Bulletin No.: 13434B
Date: May 2014

Program Bulletin

CUSTOMER SATISFACTION PROGRAM

SUBJECT: Air Conditioning System Inoperative or Cools Intermittently

3828227

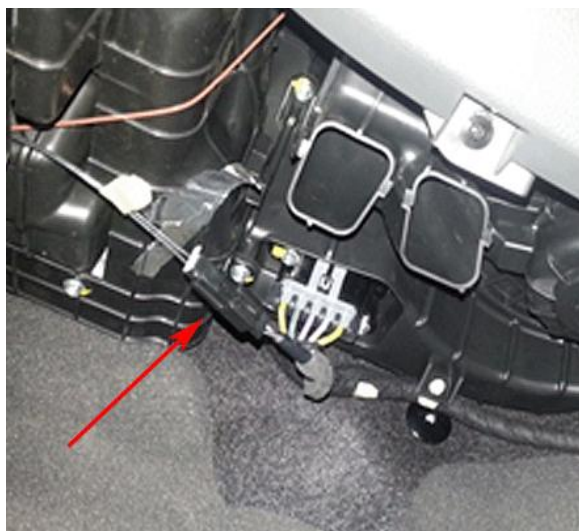
The switch installation procedure has been revised. A Caution statement has been added before Step 2, a revised illustration for Step 18 has been added, and Steps 26 & 27 have been revised. Please discard all copies of bulletin 13434A.

18. Connect the connector to the Low Pressure Switch and attach the new harness with C-clips to the A/C pipe.
